**White Farm Equipment Company**  
WHITE MOTOR CORPORATION

## Service Bulletin

Location Charles City  
Subject Transmission Disengagement —  
1250A, 1255, 1265, G350,  
1355, 1365, G450  
Number 430 571  
Date 6-28-73  
File C Transmission

*Fig. 1 Correct Engagement Teeth Profile*

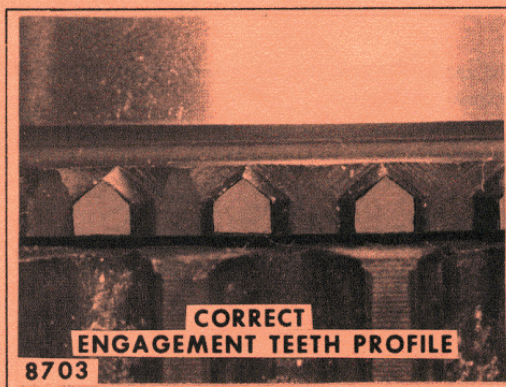
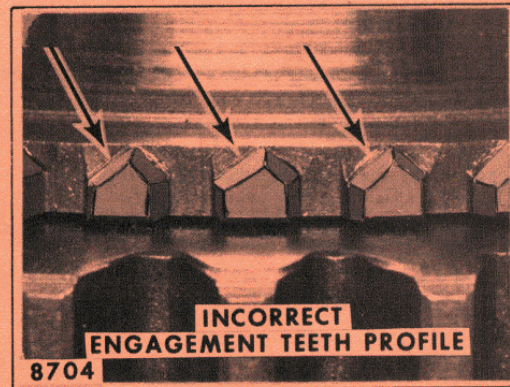
Possible gear disengagement due to incorrect machining of engagement teeth on synchromesh gear.

Incorrect machining of engagement teeth on synchromesh gear may not allow enough contact with drive collar teeth to maintain engagement (Figs. 1 and 2).

If problem exists purchase and install new synchromesh gear.
